Re: Centennial Project, C/007/0019, Emergency GVH Application

# APPLICATION FOR PERMIT PROCESSING

Title of Application: GOB GAS VENT HOLE AMENDMENT

CENTENNIAL PROJECT  
GVH LOCATION MAP  
FIGURE 1-1

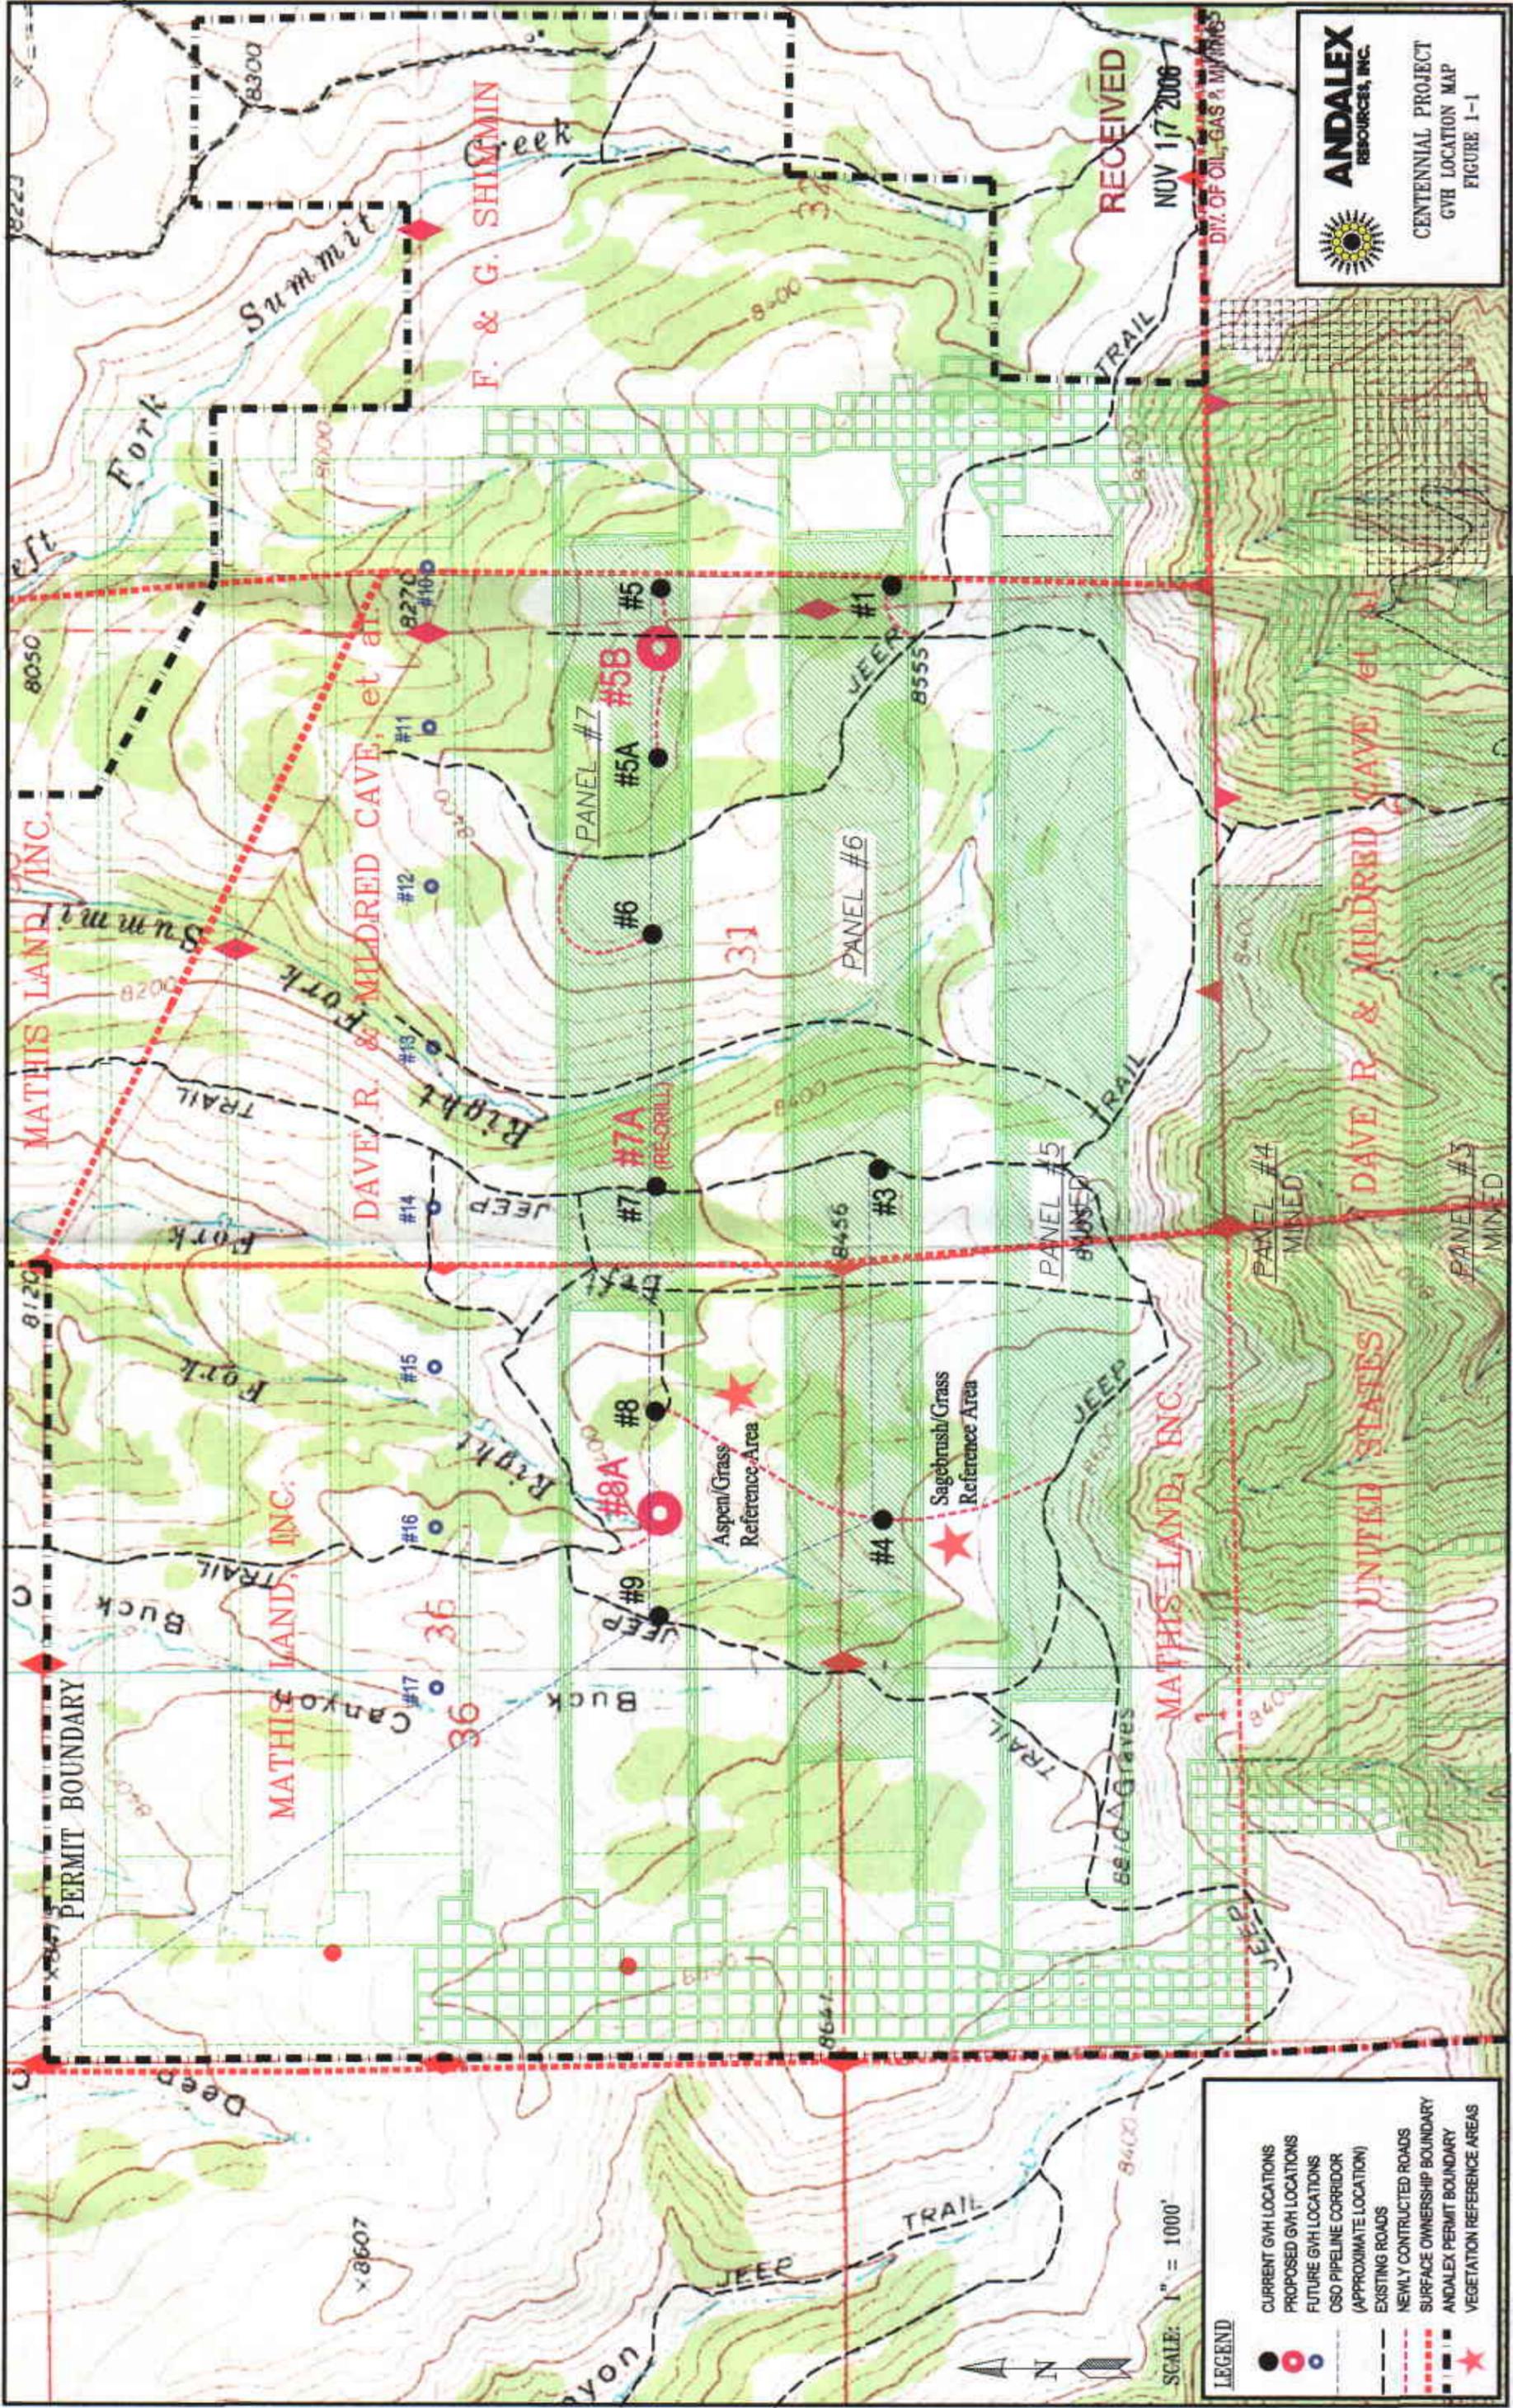
GVH-7A - This site will be a re-drill of existing site GVH-7, and will use the existing access road to GVH-7.

GVH-8A - This site will be accessed by a short spur road to be constructed from an existing road which presently provides access to GVH-9. The existing road extends beyond GVH-9 and trends eastward into the draw between GVH-8 and GVH-9. The spur road will be approximately 300' long. The existing road and the access spur will be approximately 16' wide with an average grade of approximately 8.5%. The road construction will be on native material with runoff control primarily by ditches. The spur road will be removed and reclaimed unless otherwise directed by the landowner.

It should be noted that the spur road will cross the Right Fork of Antone Creek, which is an ephemeral drainage at this location. Special care will be taken to protect the drainage, which may include silt fences, berms, ditches and/or temporary culverts, as needed.
